Model: Model PL-MF		Date: 2-Oct-06	No.: MG157001
Modified Article: Transfer Roller		Prepared by: H.K.	
From: Technical Service Dept., GTS Division			
Reason for Modification:	<input type="checkbox"/> Parts catalog correction <input type="checkbox"/> To facilitate assembly <input type="checkbox"/> Part standardization	<input checked="" type="checkbox"/> Vendor change <input type="checkbox"/> To improve reliability <input type="checkbox"/> Other	<input type="checkbox"/> To meet standards ()

Change: The material of the transfer roller was changed.

Reason: Vendor change

11: V121372: MSL1 SHIELD COVER A

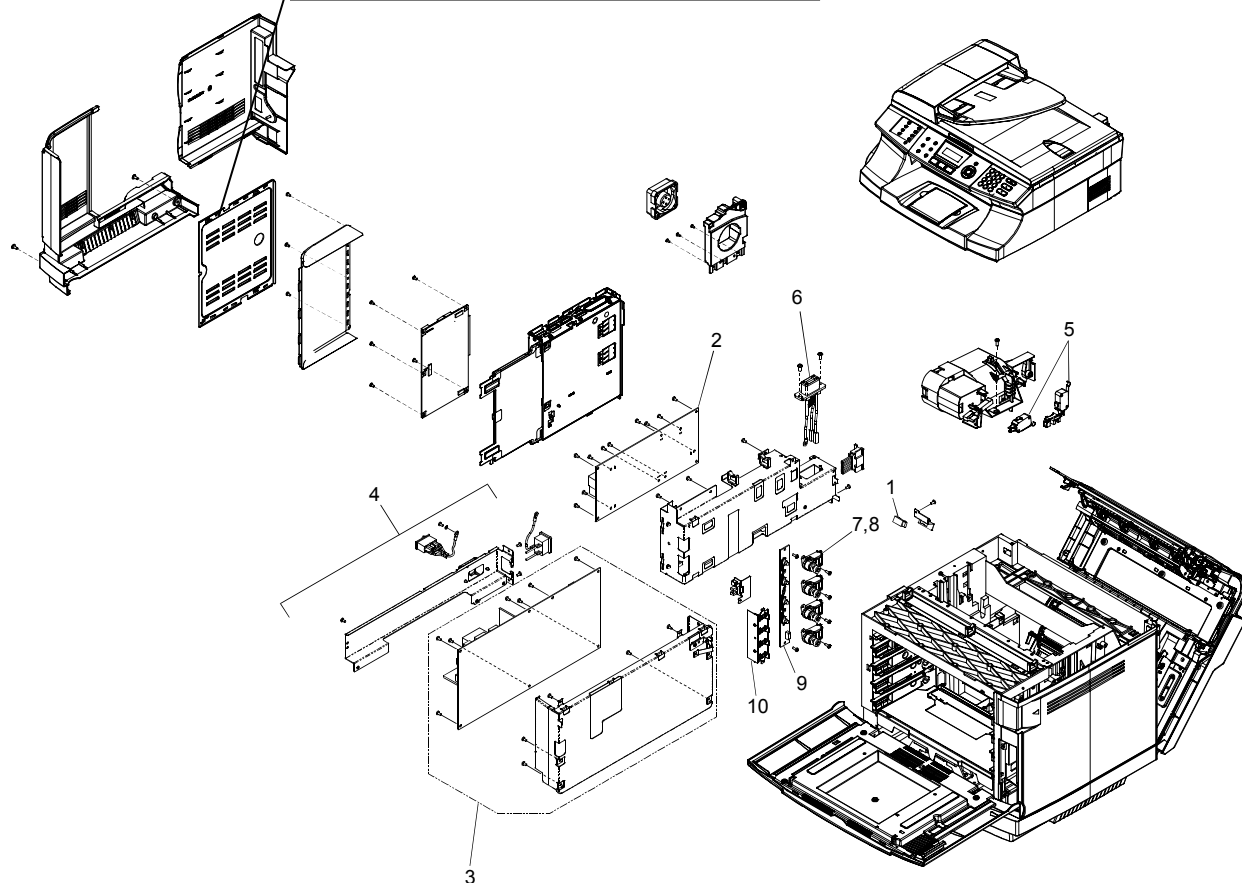
Change: This part was added.

Reason: It was missing from the Parts Catalog.

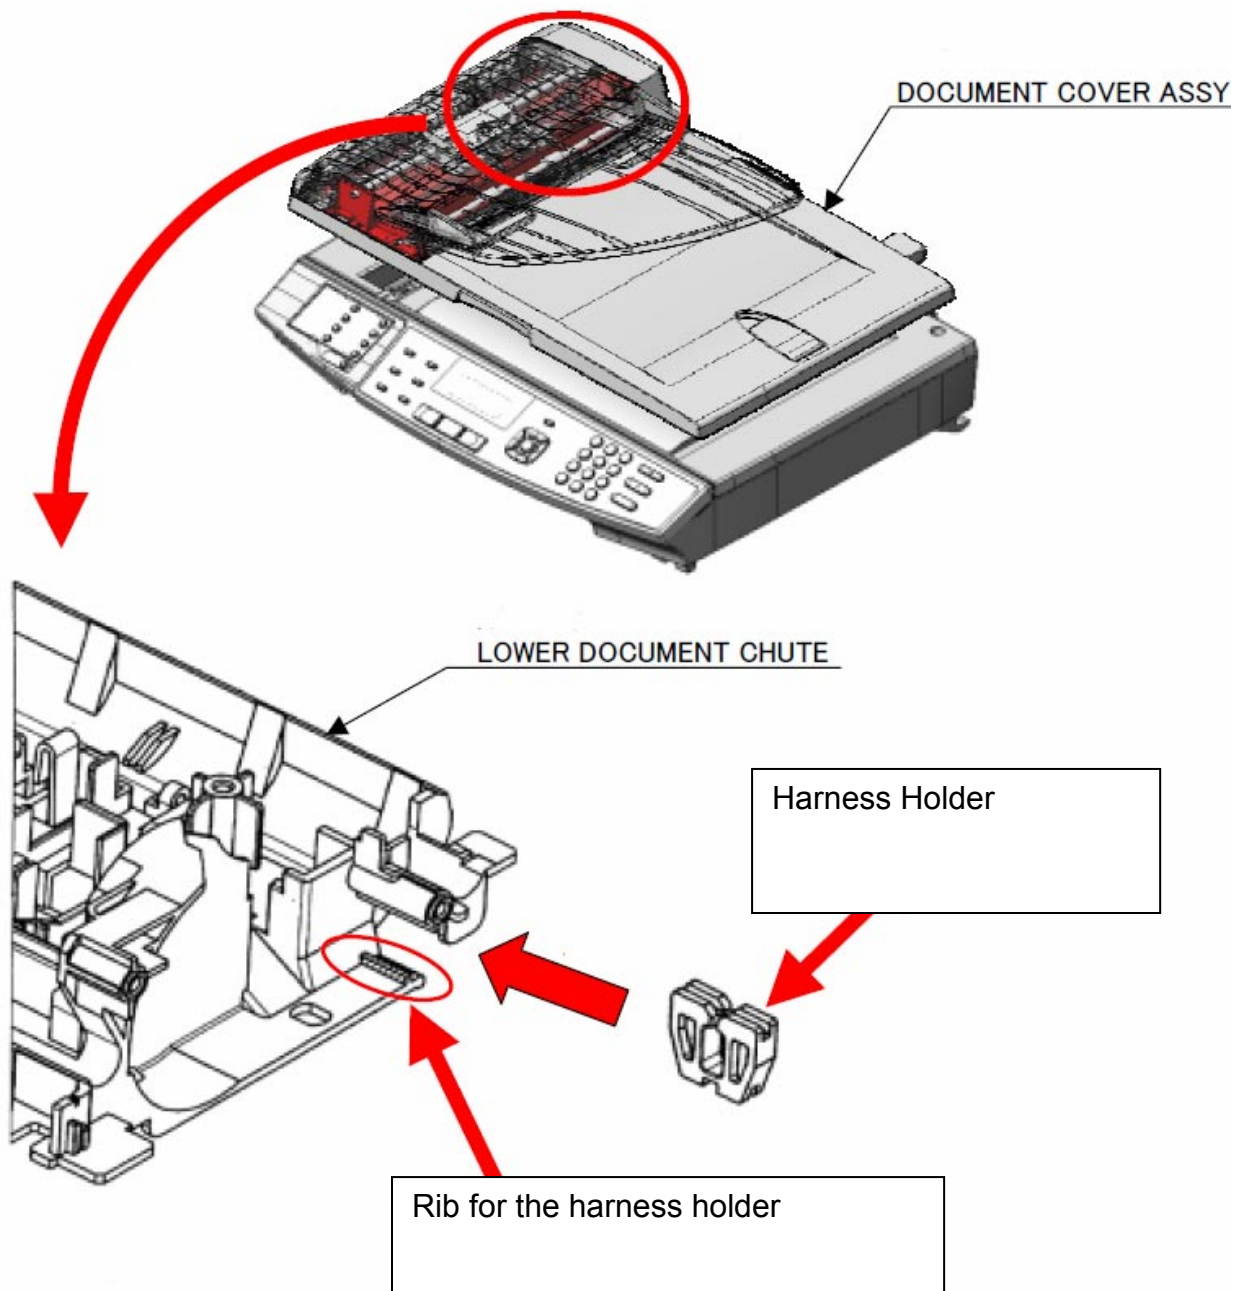
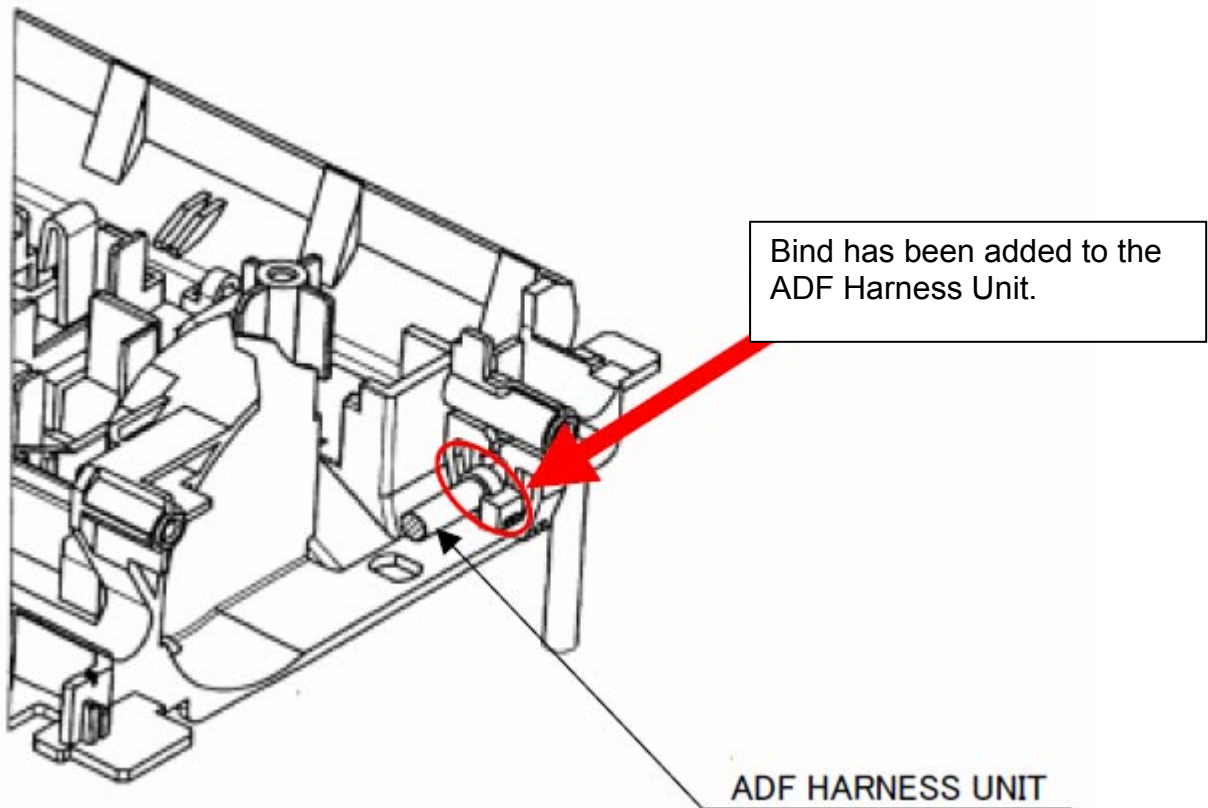
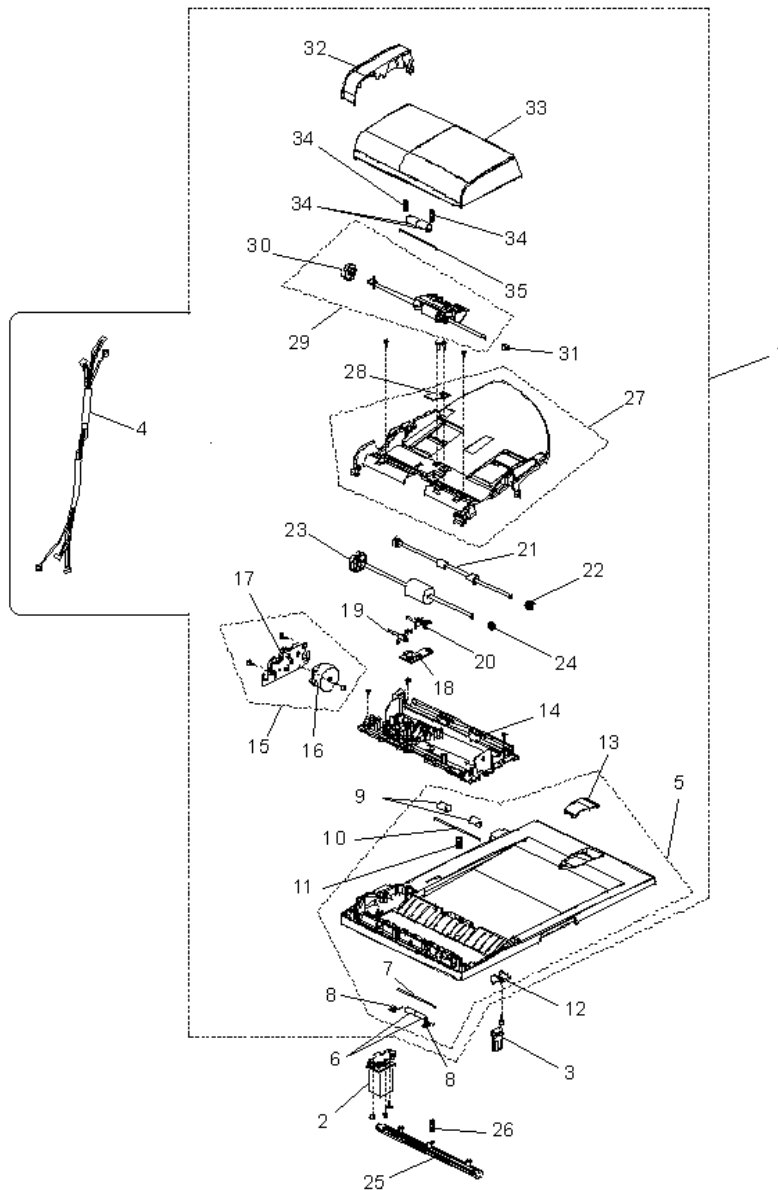
- 1) A harness holder was added to the Lower Document Chute.
- 2) A bind was added to the ADF Harness Unit Ass'y.

Reason: To further ensure the harnesses stay connected during factory assembly.

ADF Harness Unit Ass'y (4) is included into DOCUMENT COVER ASS'Y (1).

REGIST GROUND SRING

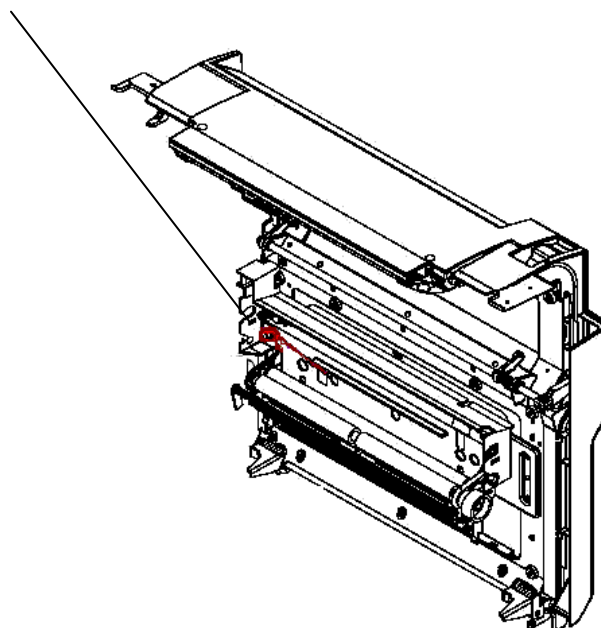
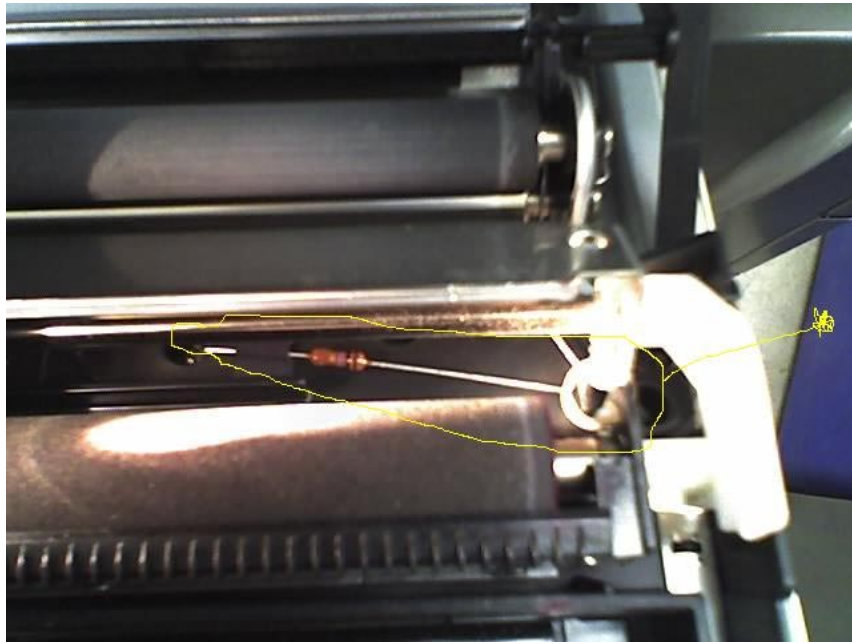
Change: The part in the table was added.

Reason: Requests were received from the field.

Important: Handle this spring carefully. Make sure not to deform or bend the spring, as this can cause jams, noise, or poor image transfer.

SC Base L/R KIT

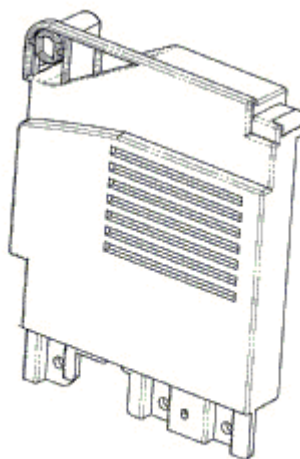
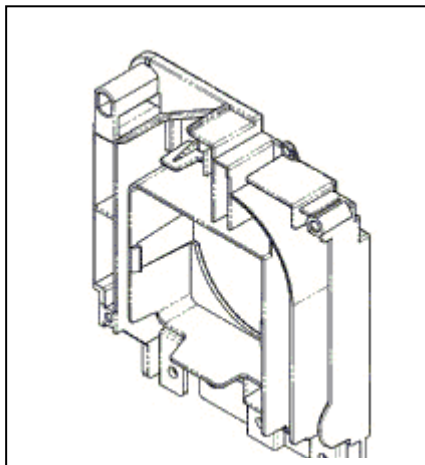
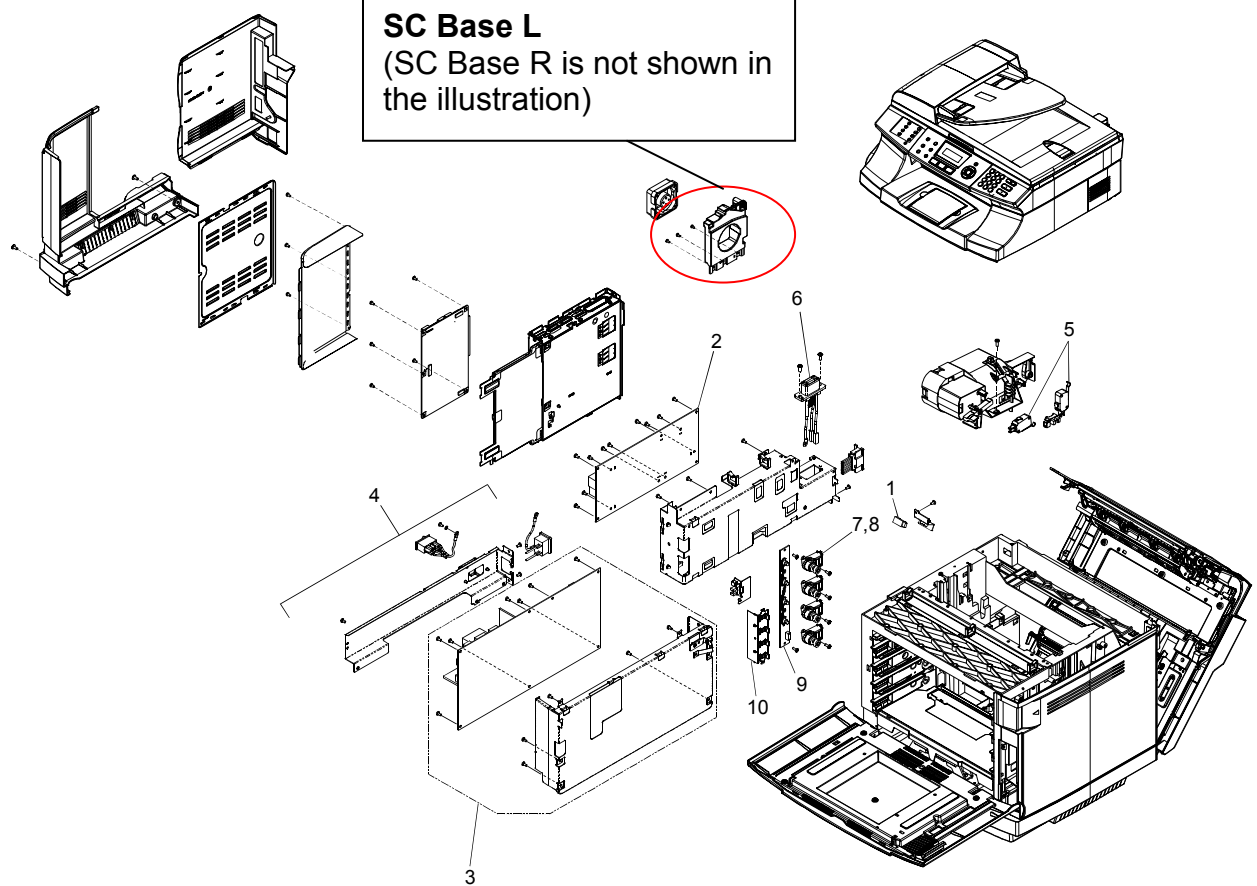
Change: This part was added.

Reason: As per a request from the field.

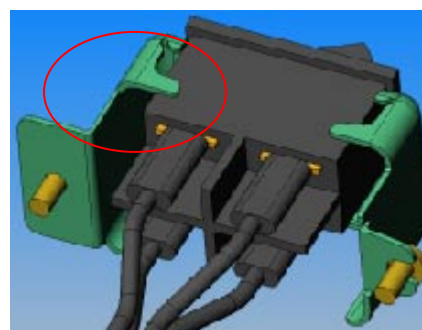
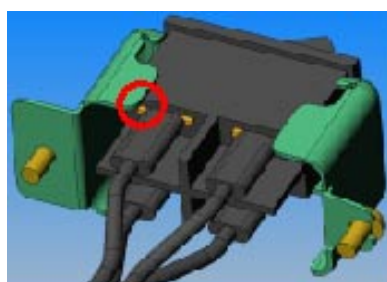
Change: The shape of the bracket was changed.

Reason: To meet European standards.

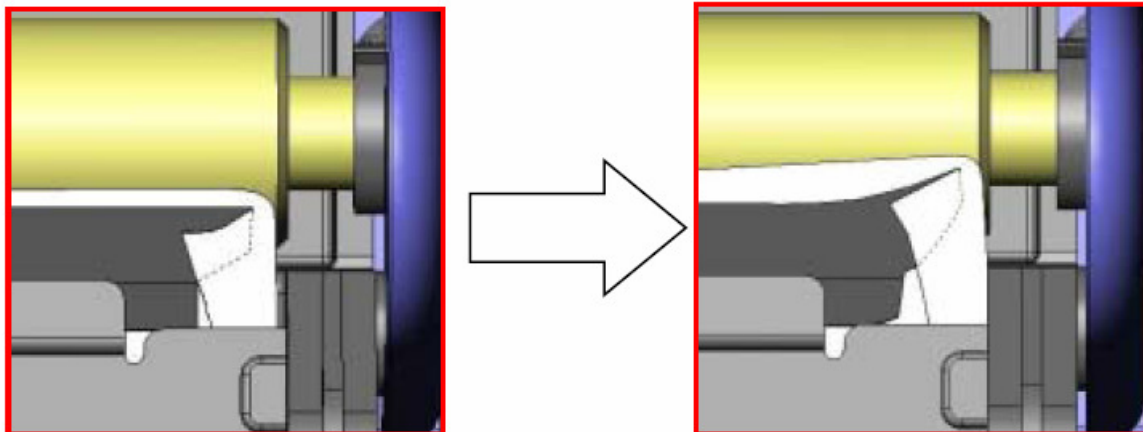
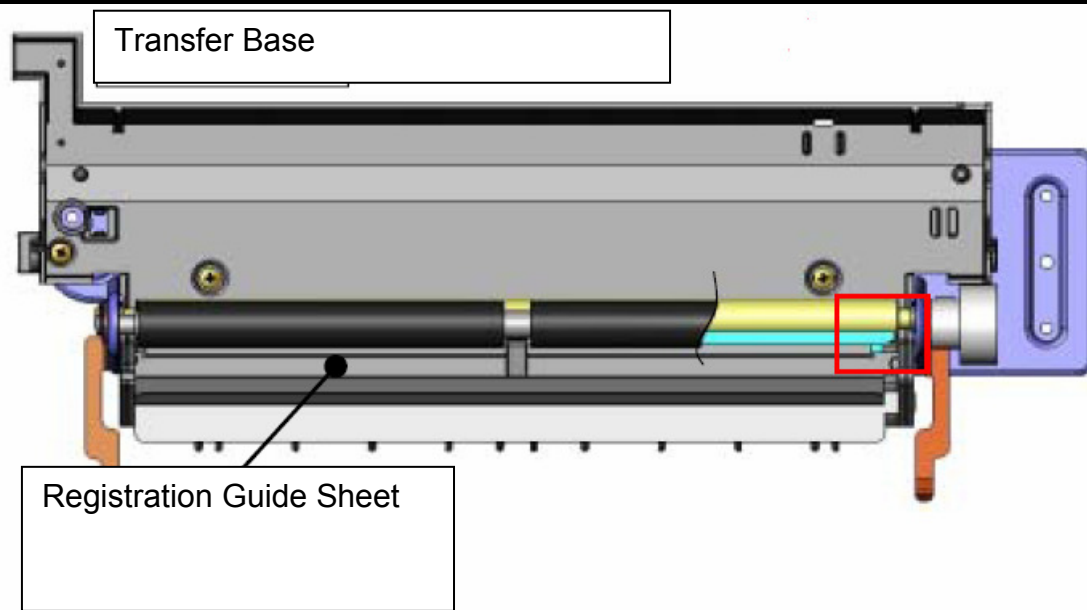
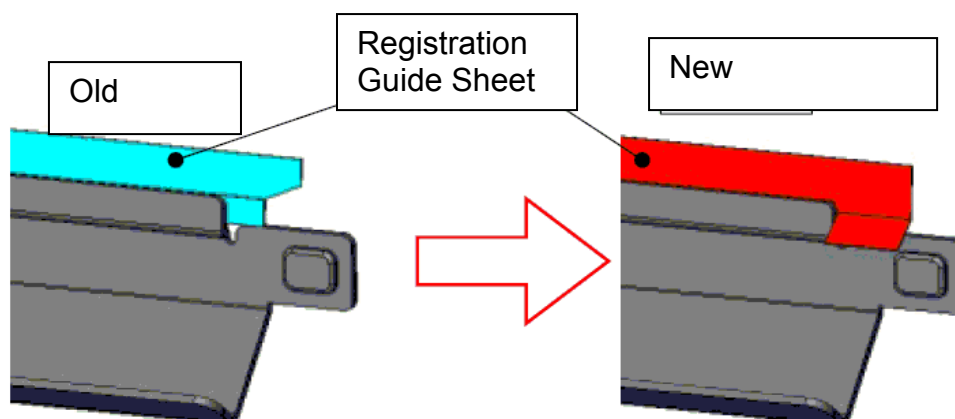
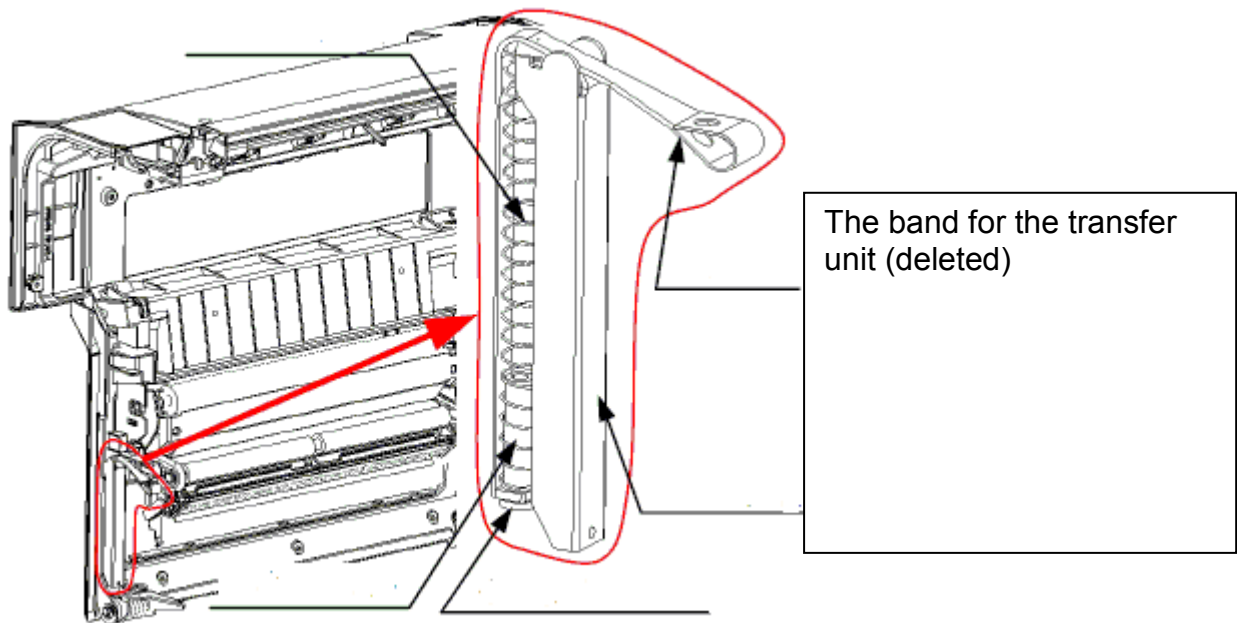
- 1) The shape of the registration guide sheet on the transfer base was changed.
- 2) The band of the transfer unit was deleted.

- 1) To ensure that the guide sheet is not bent by paper that is skewed during paper feed
- 2) To facilitate assembly on the production line.

Note: The band of the transfer unit was removed, but the existing spring and hinge mechanism will stop the rear cover halfway when it is opened.

Skewed paper may bend the old registration guide sheet.
